SUBJECT: Forwards copies of responses to NRC 780918 ltr requesting
 addl info re Instrumentation & Controls Sys. Responses to
 be formally inserted in FSAR as an Amend in Feb 1979.
(see reports)

G02-79-04
January 5, 1979

Subject: WPPSS NUCLEAR PROJECT NO. 2
RESPONSES TO INSTRUMENTATION AND CONTROL
BRANCH, REACTOR SYSTEMS BRANCH, AND
HYDROLOGY-METEOROLOGY BRANCH QUESTIONS

EWA SAL 00 05 Rev C
NRC QUESTION # 031.65

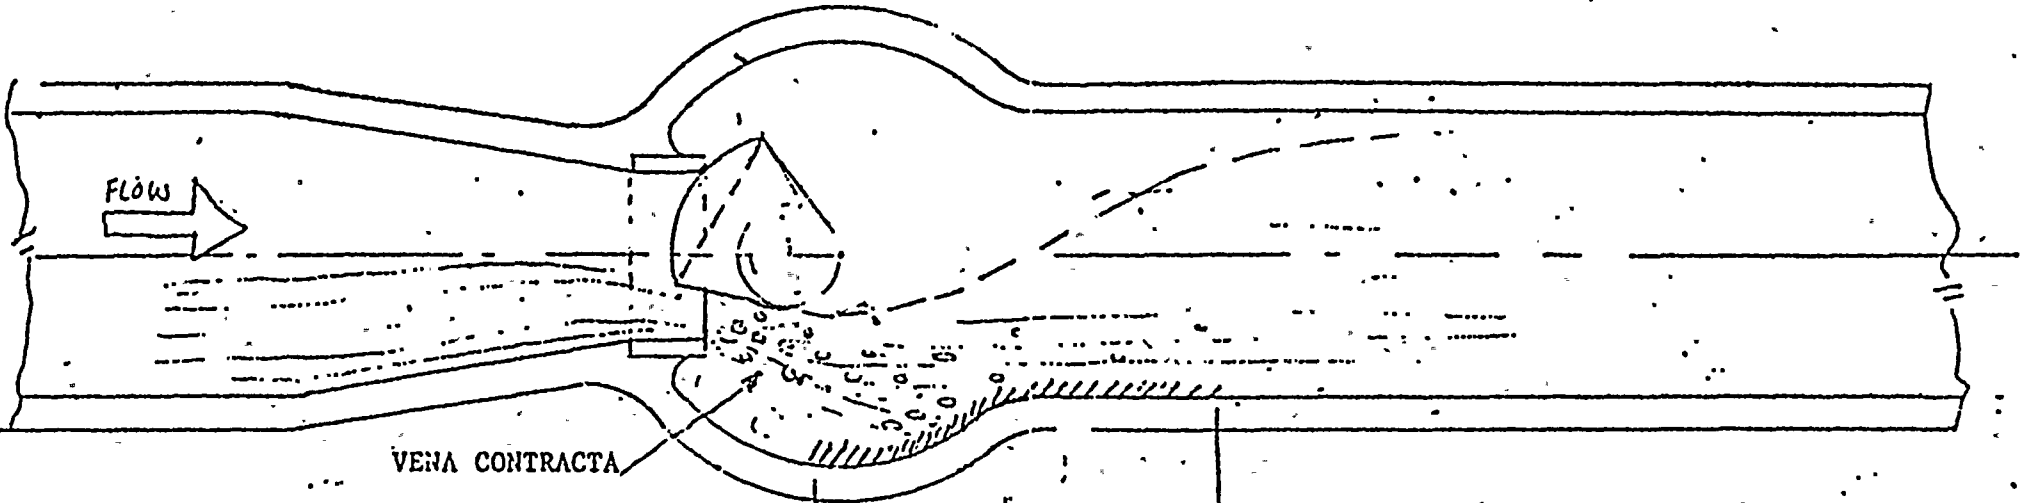
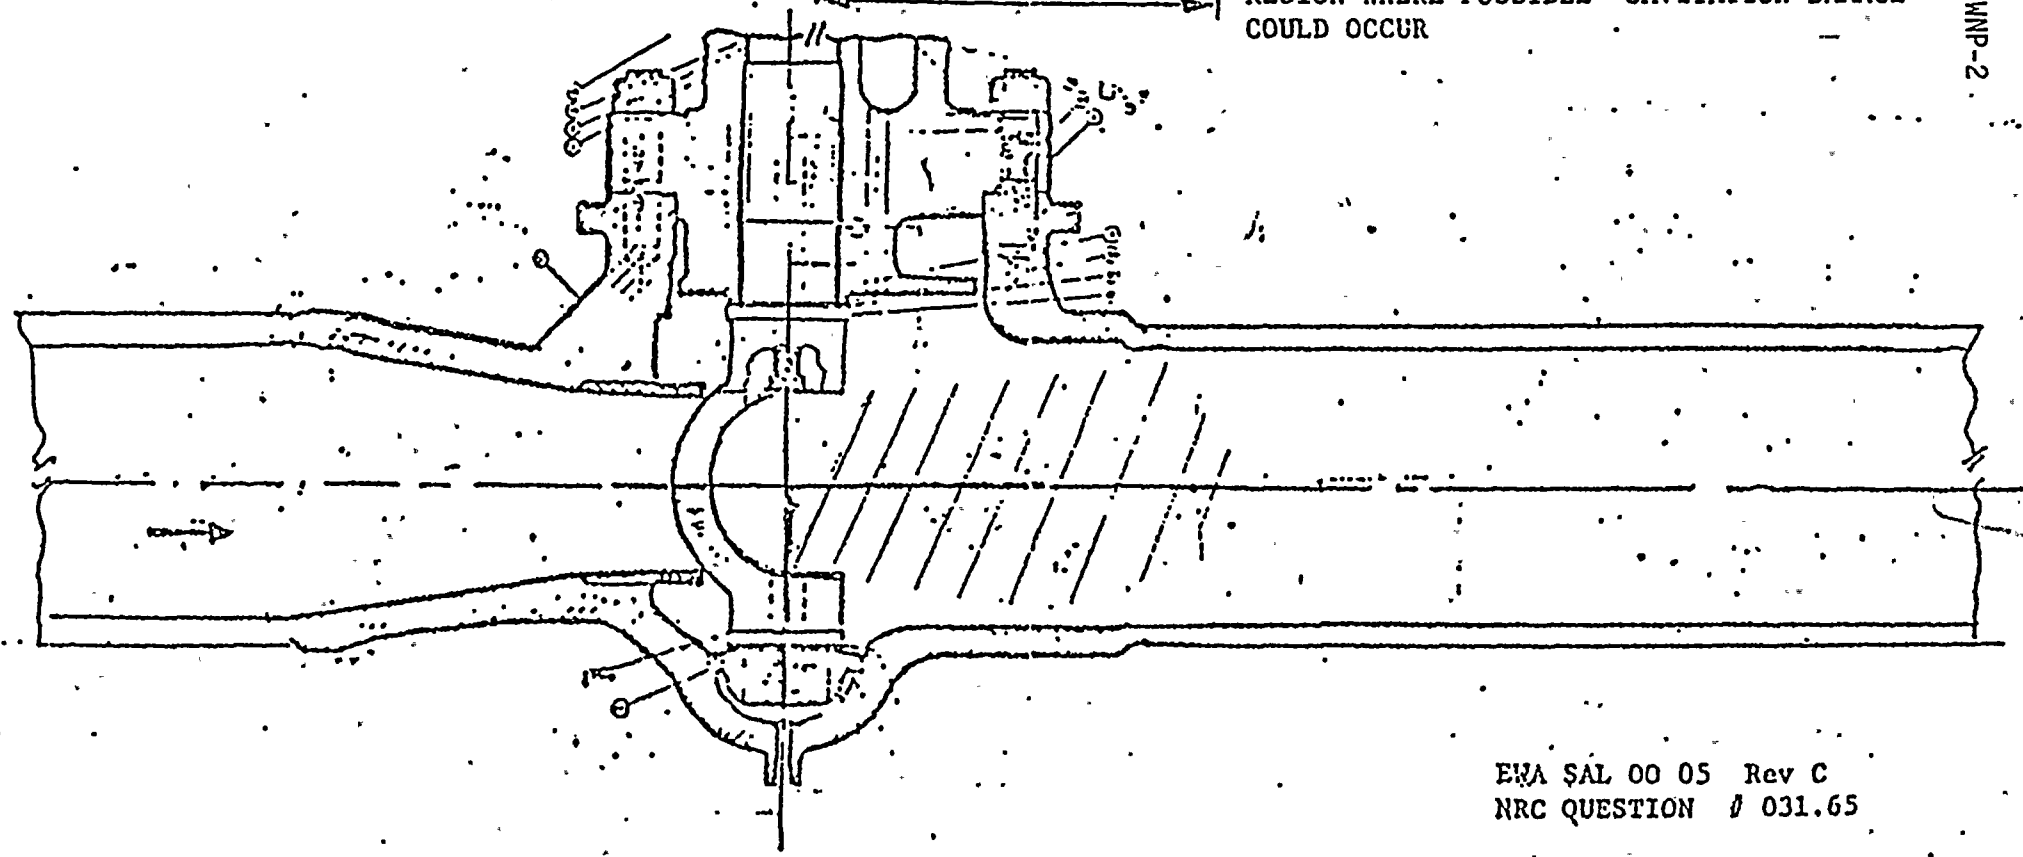
Your response to Item 031.010 is incomplete. Identify the specific recirculation flow control valve components which would be damaged by the collapse of bubbles in the pressure recovery areas of these valves.

In response to 031.065, enclosed is a figure which describes where possible cavitation damage could occur by the collapse of bubbles in the pressure recovery areas of the flow control valves.
